# TECH BULLETIN

084  
11/99

## SUBJECT: Crankcase Change - 60 Frame

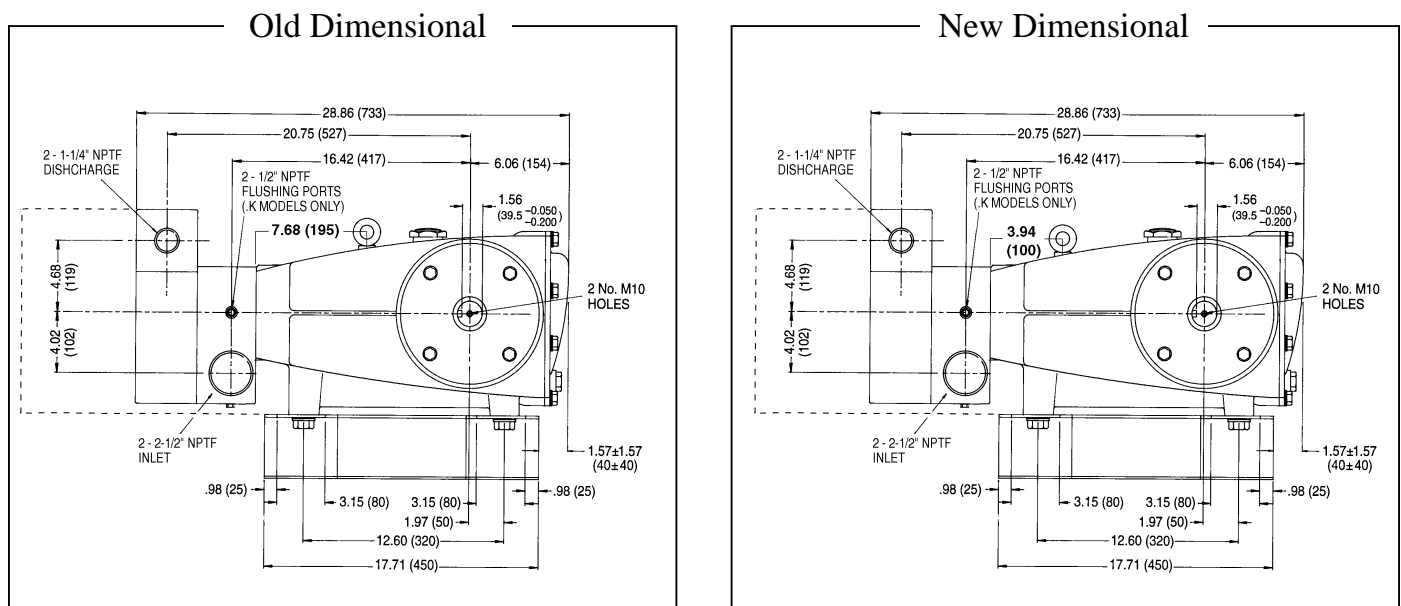
The 60 Frame Crankcase lifting eye bolt has been relocated to a more forward position. This has been done to provide better balance with the increase popularity of the block-style heads. This change will take place approximately January 2000 and the crankcase PN 43284 will continue to be used. A recess has also been added at the top of the crankcase for the label.
